**SOUTH VALLEY WATER RECLAMATION FACILITY  
WEST JORDAN, UTAH**

**PROJECT 5**

**ADDENDUM NO. 5  
TO THE  
CONTRACT DOCUMENTS**

**MAY 16, 2019**

DRAWING NO.  
**GE-OL-21-2**

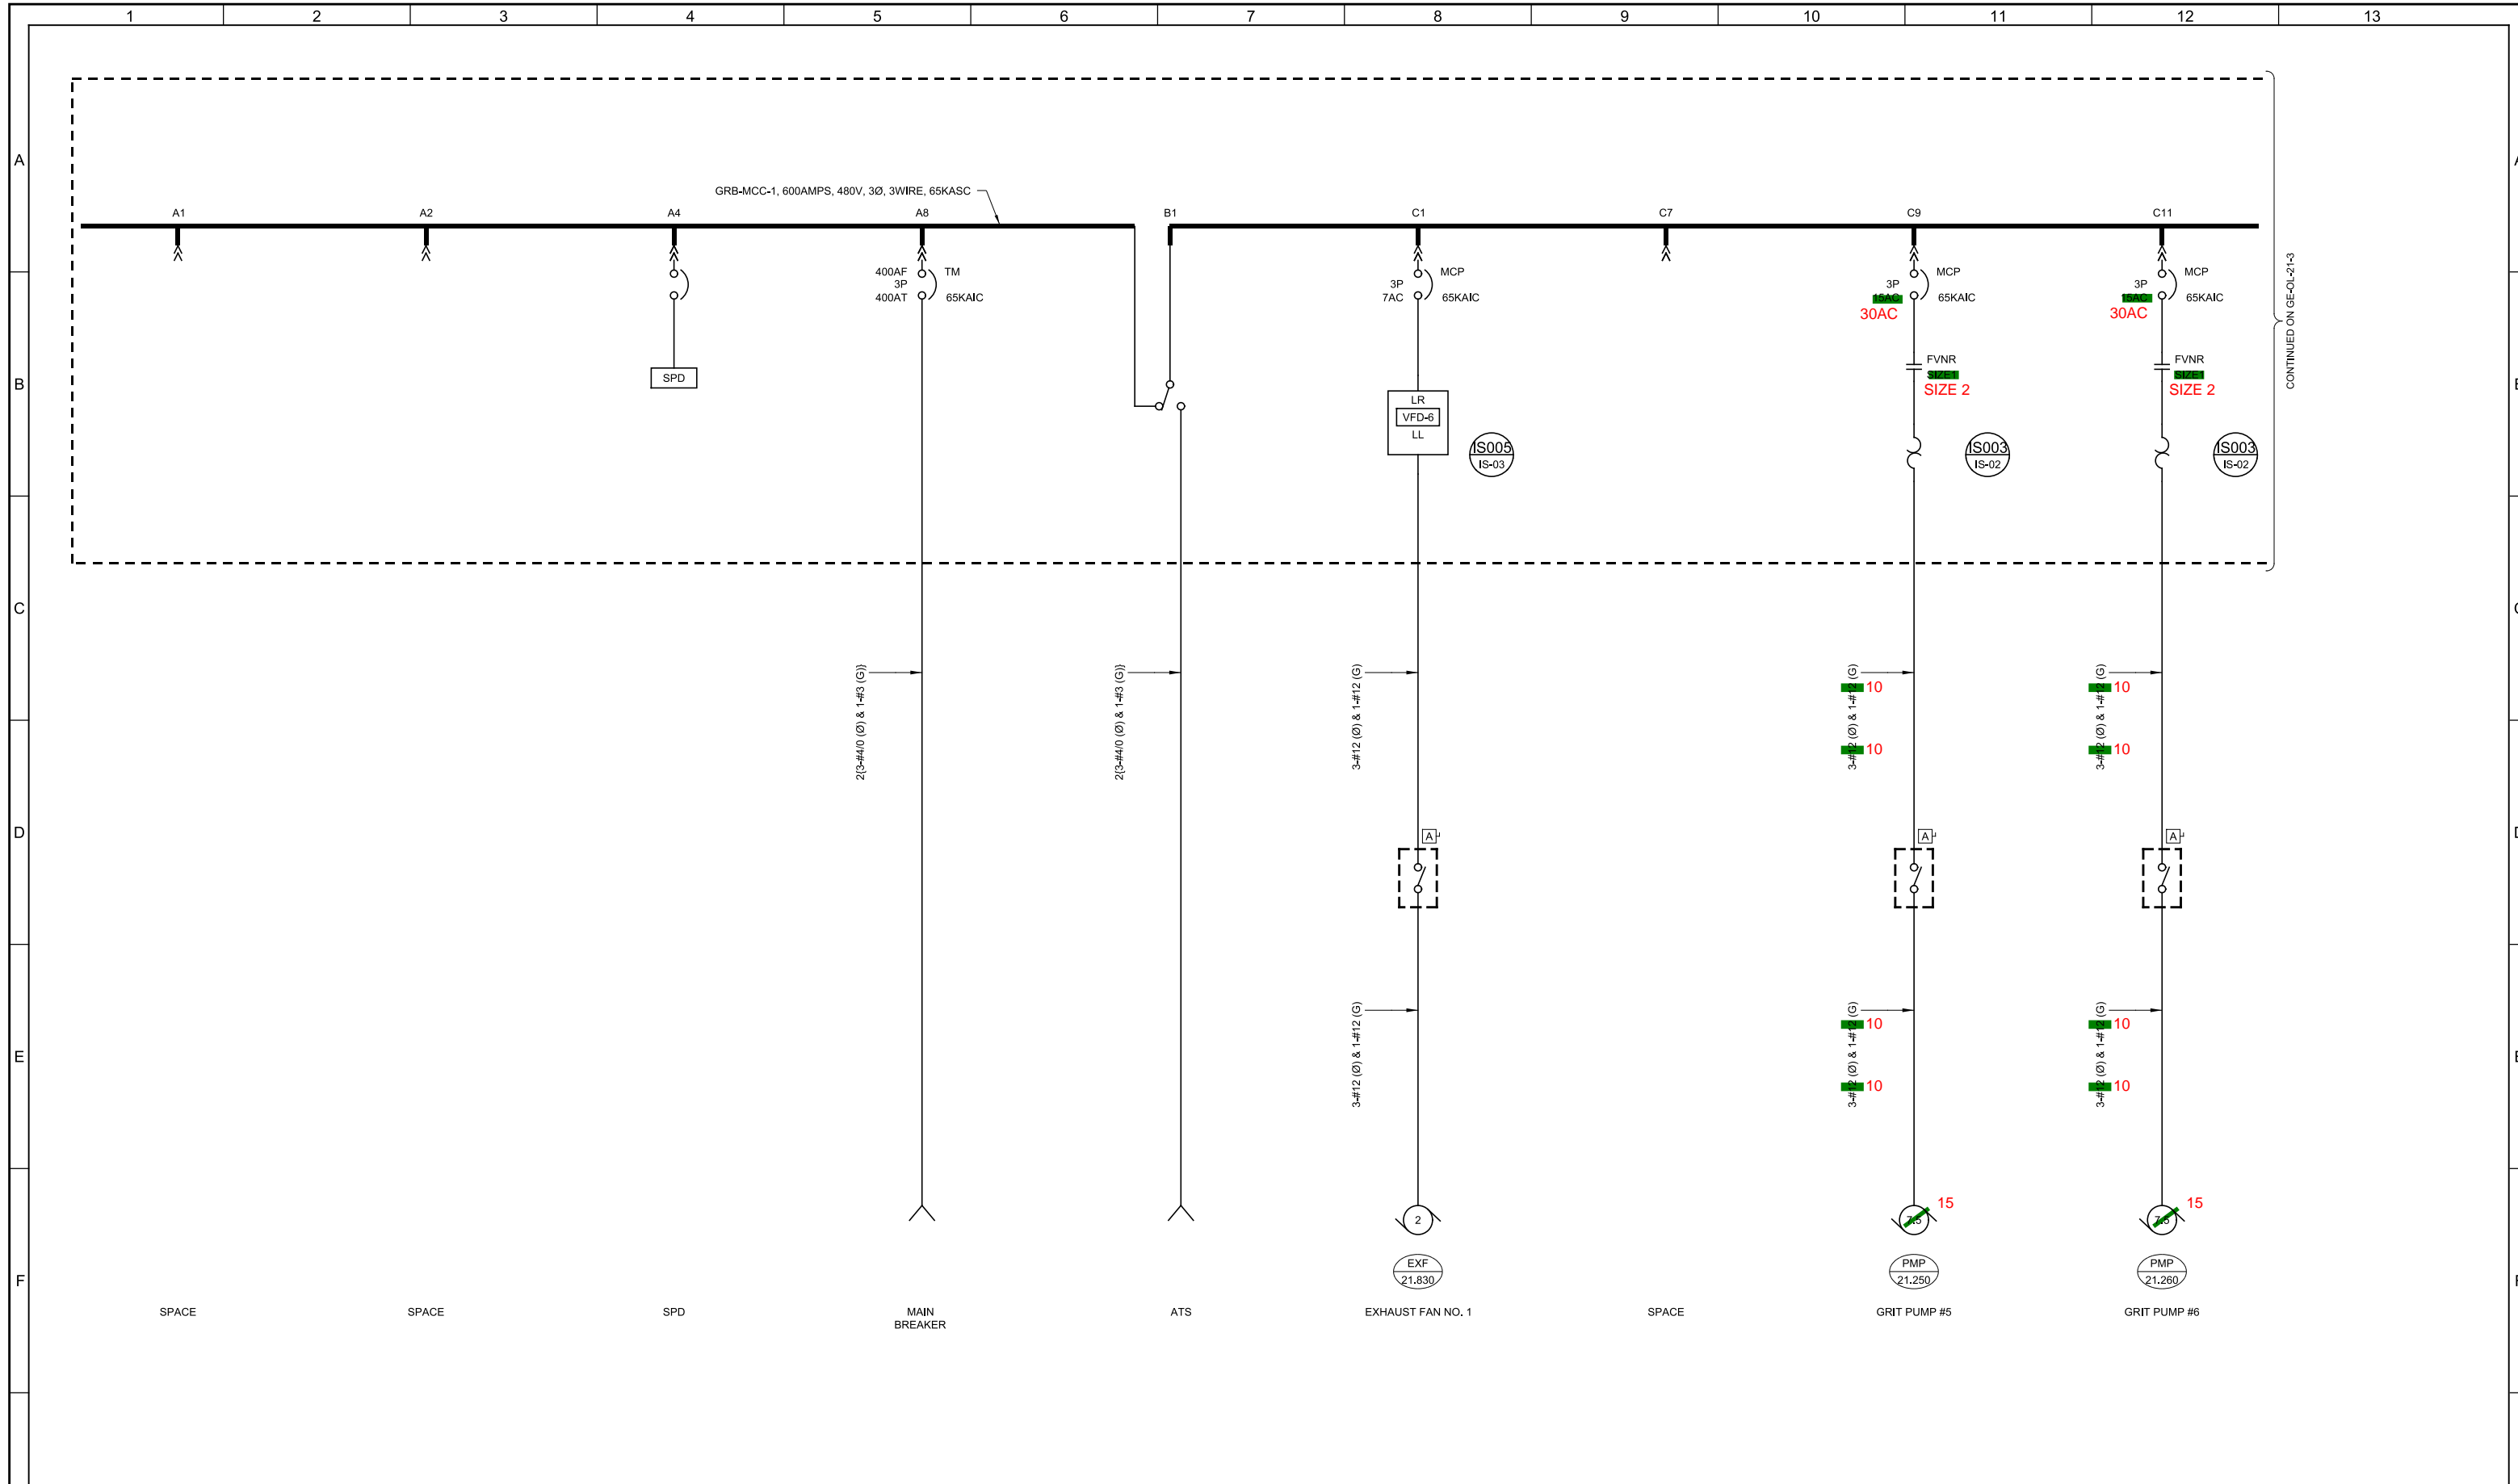
- Room No. 103 - Grit Pump Room.
      - Room No. 201 - HVAC Room.
      - Room No. 202 - Grit Washing Room.
3. DRAWING GE-OL-21-2
  - a. Change the HP of PMP-21.250 and PMP-21.260 to 15 HP and make changes to conductors, starters, and MCP rating as shown in attached Drawing GE-OL-21-2 to accommodate HP change.

DRAWING NO.  
**GE-OL-21-3**

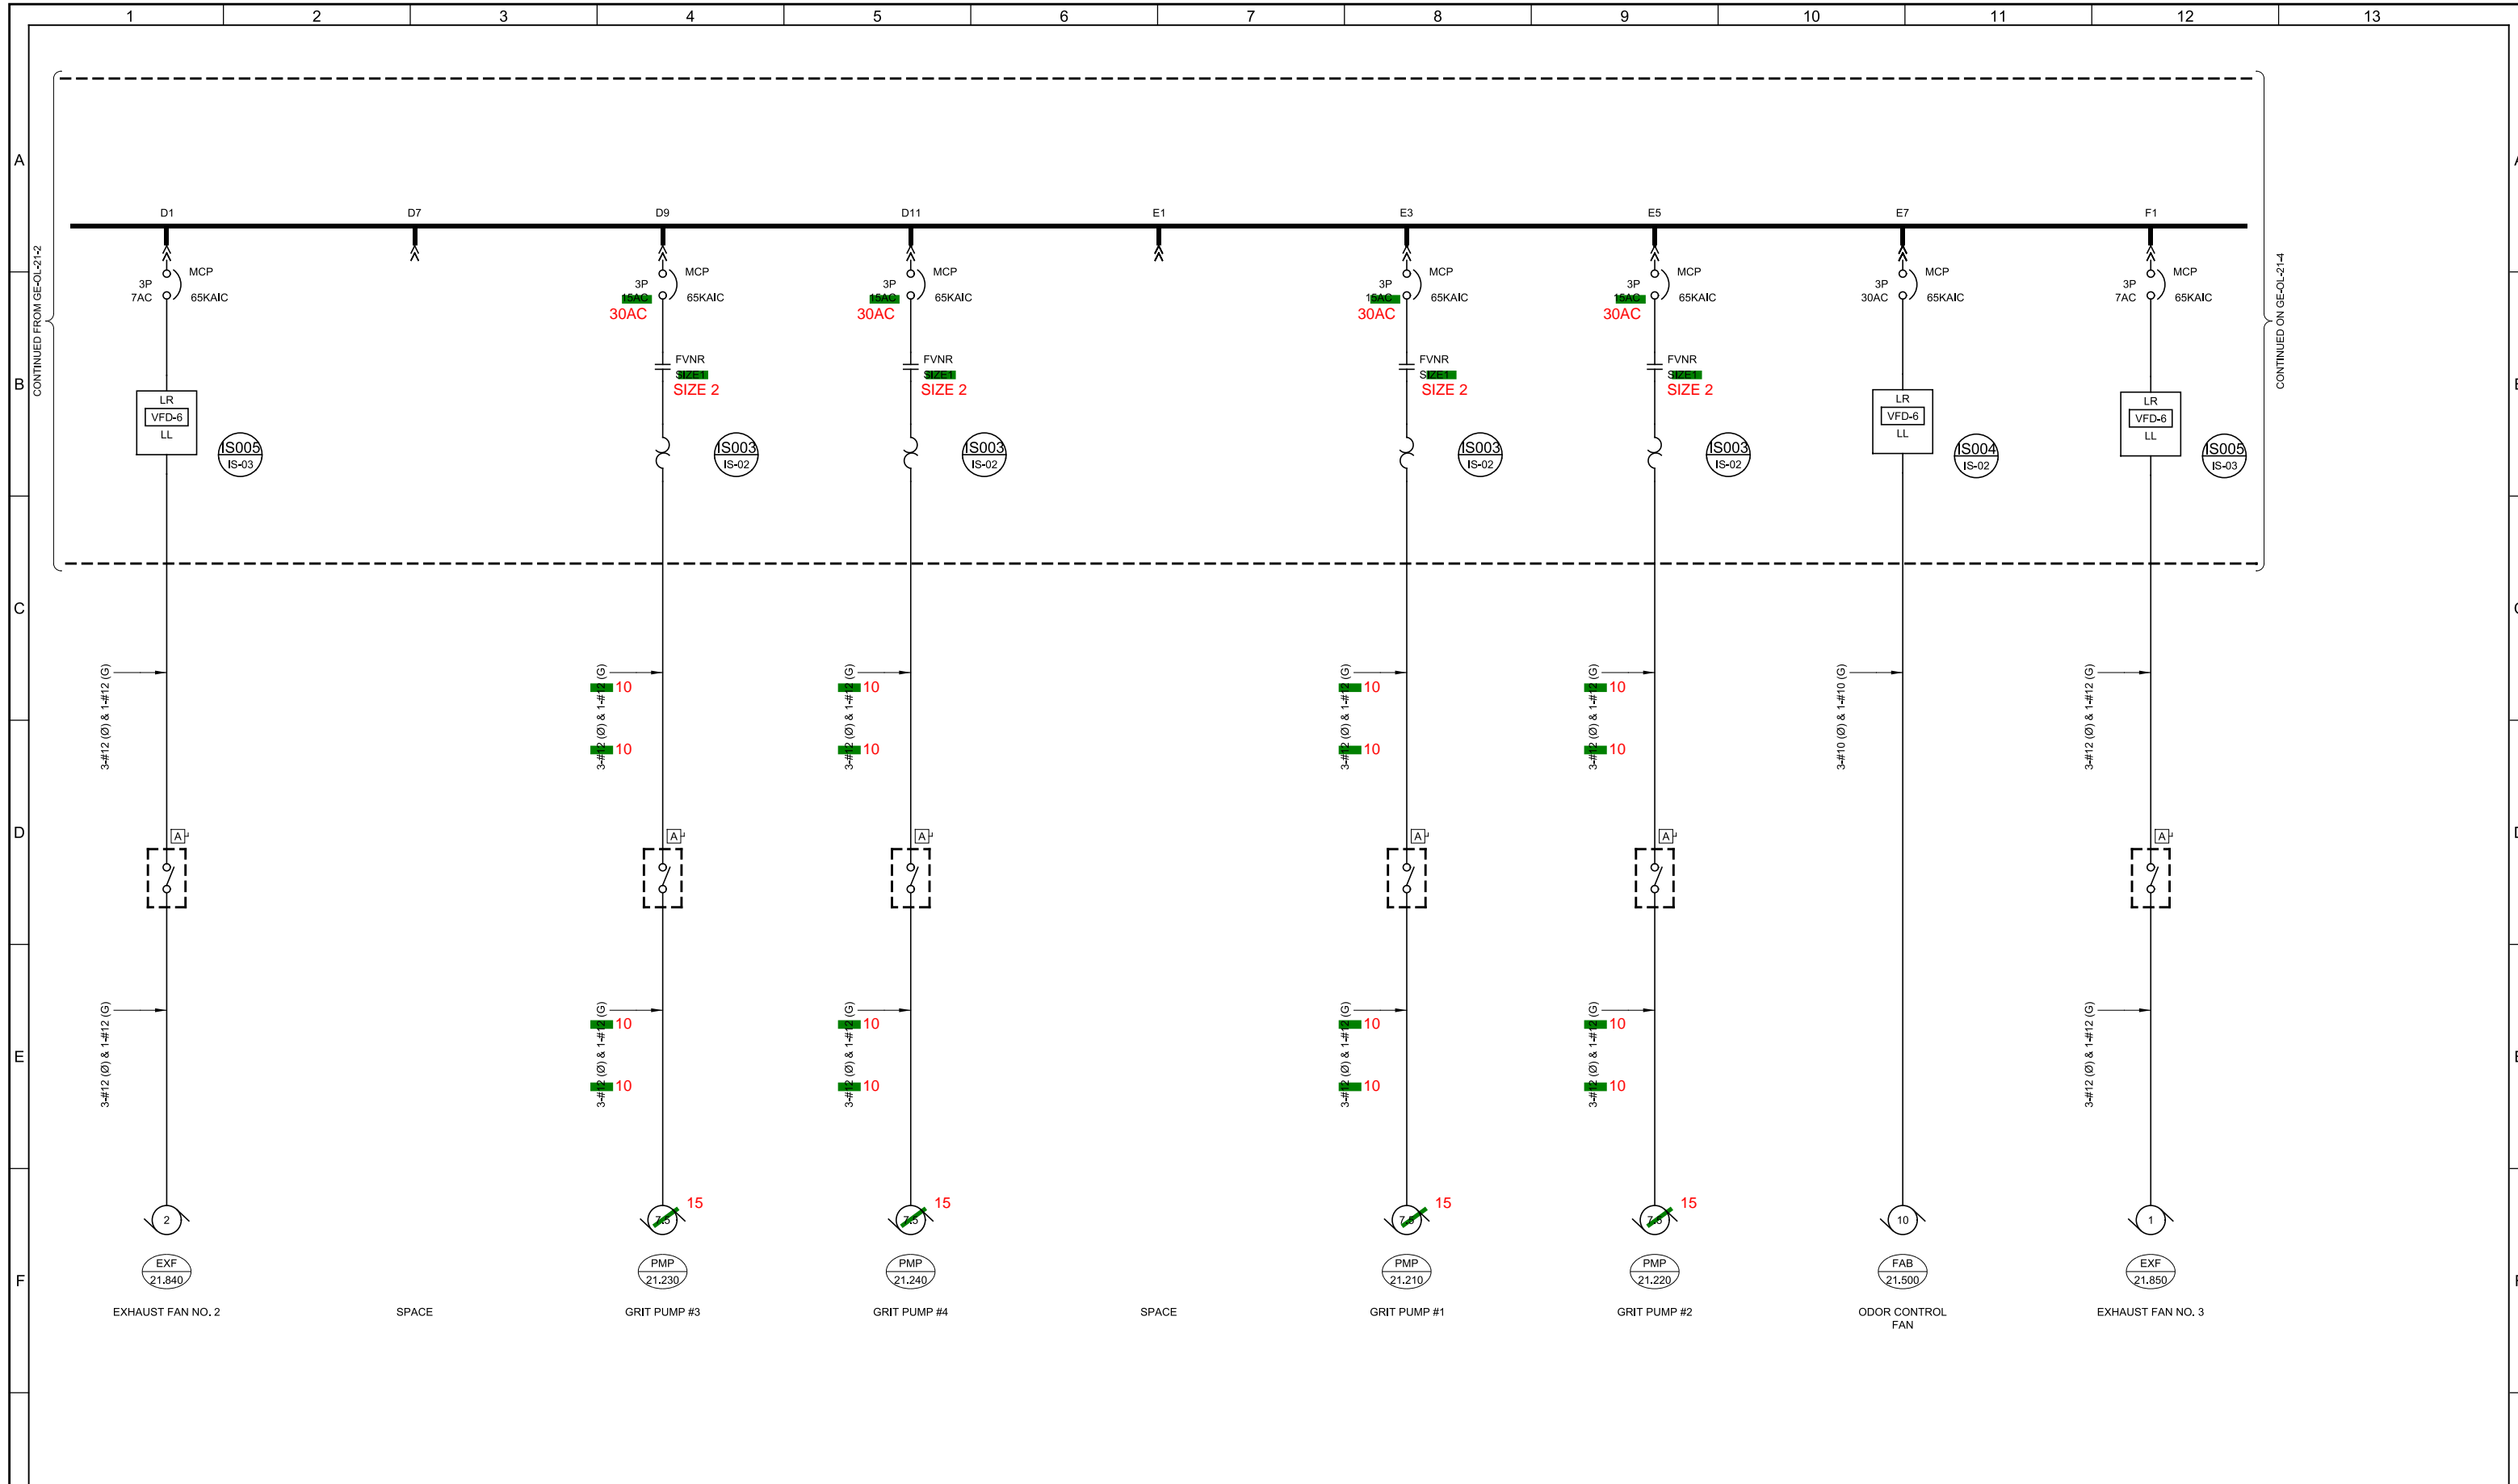
4. DRAWING GE-OL-21-3
  - a. Change the HP of PMP-21.210, PMP-21.220, PMP 21.230, and PMP-21.240 to 15 HP and make changes to conductors, starters, and MCP rating as shown in attached Drawing GE-OL-21-3 to accommodate HP change.

VERIFY SCALES	JOB NO. 10548A.10
BAR IS ONE INCH ON ORIGINAL DRAWING	DRAWING NO. GI-11
0 1"	SHEET NO. 82 OF 159
IF NOT ONE INCH ON THIS SHEET, ADJUST SCALES ACCORDINGLY

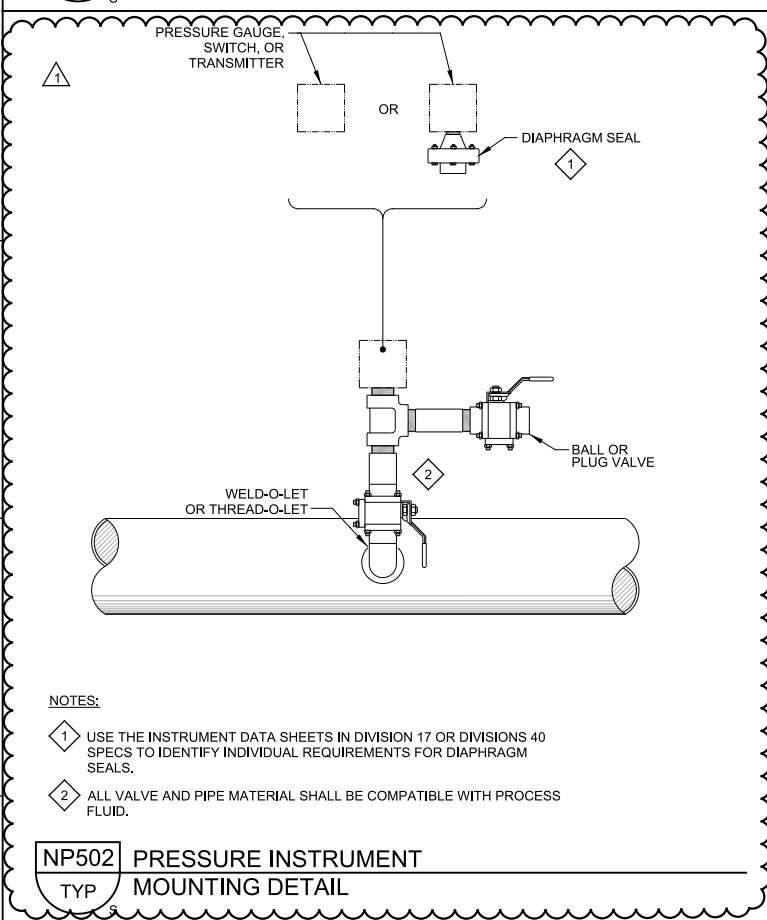
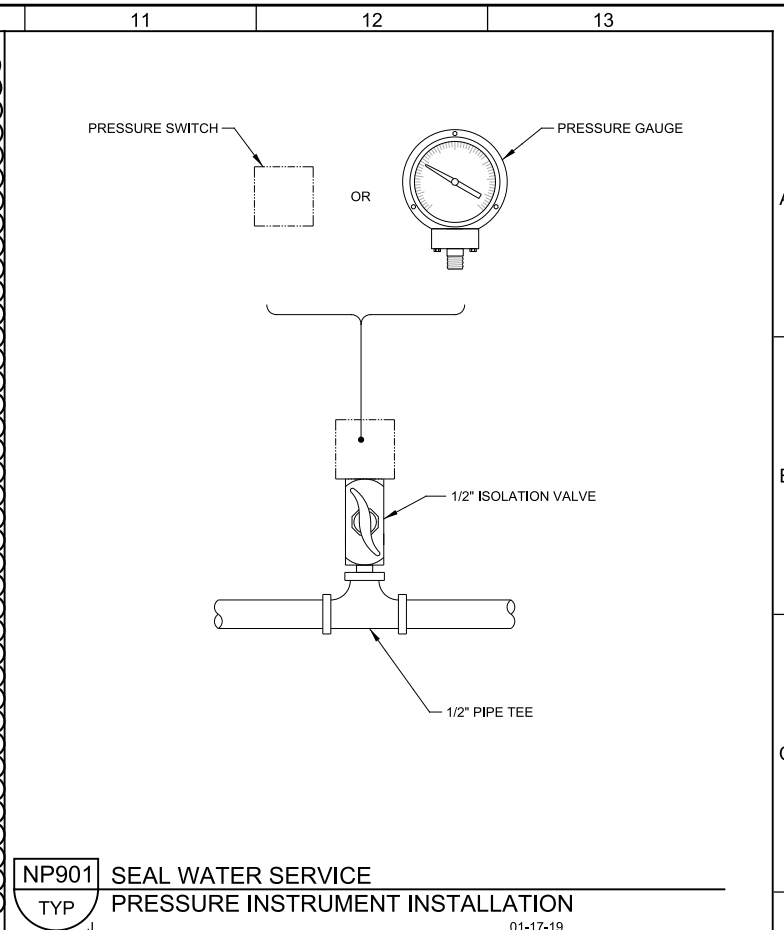
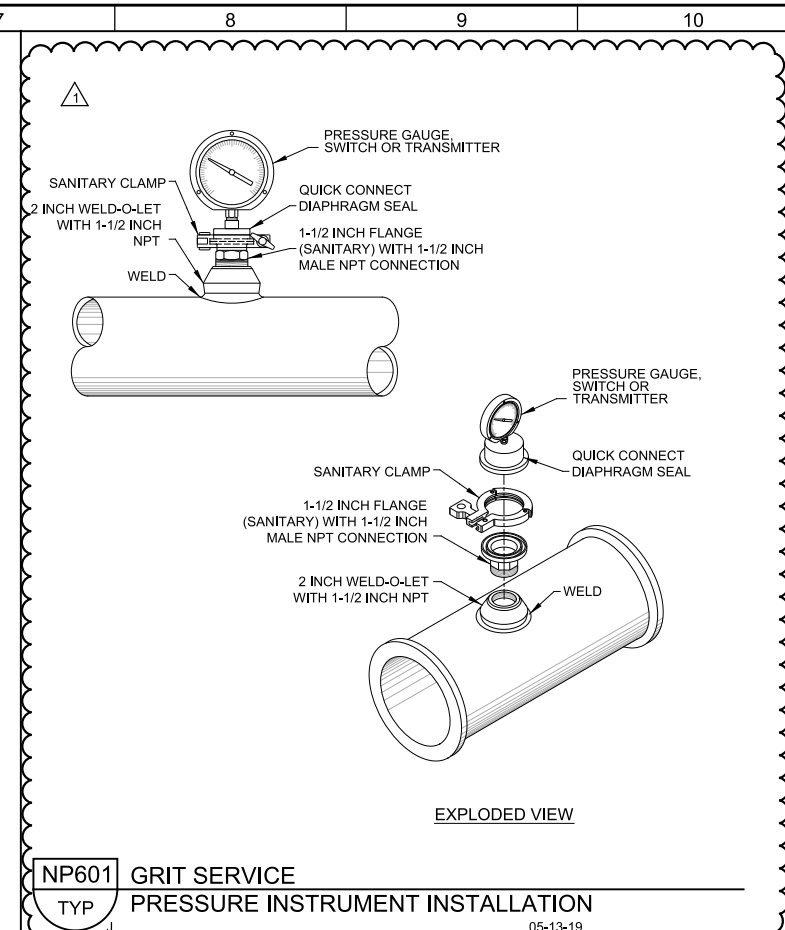
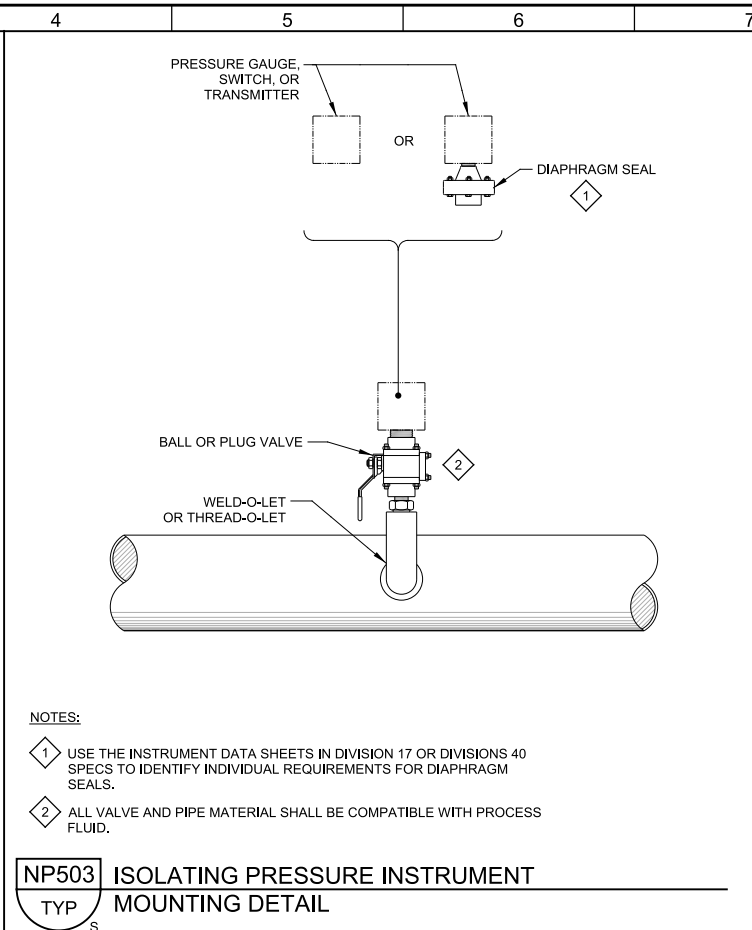
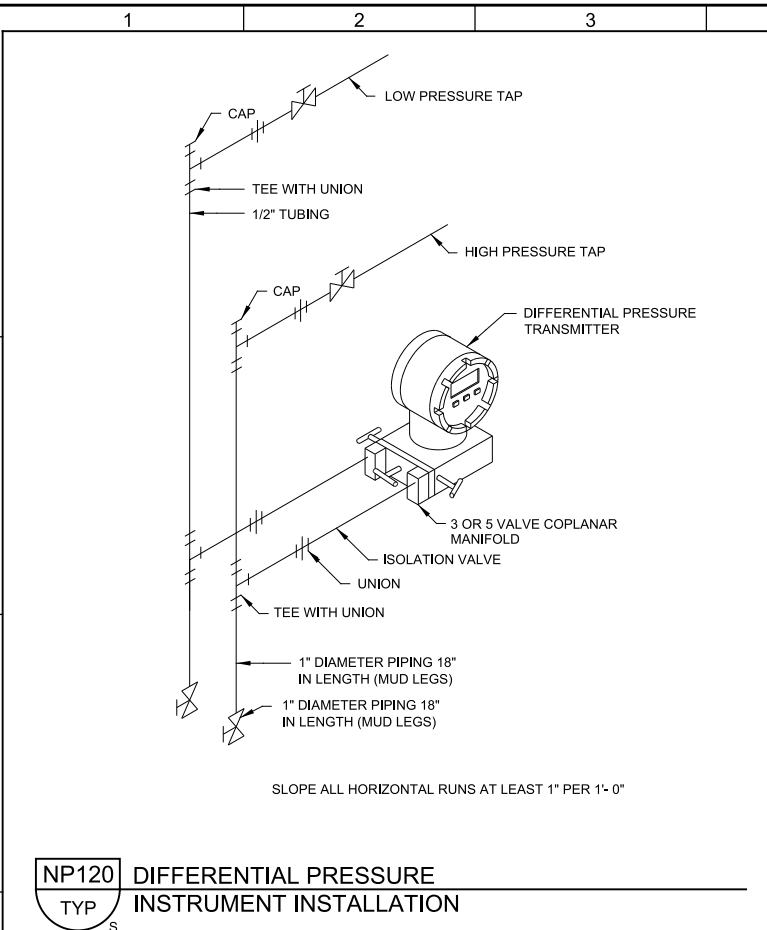
5. DRAWING GI-11 (INSTRUMENTATION TYPICAL DETAILS)
  - a. Replace current Drawing GI-11 with updated attached Drawing GI-11.
6. DRAWING PI21-04
  - a. Revise typical detail callout from NP503 to NP901 for the following instruments:
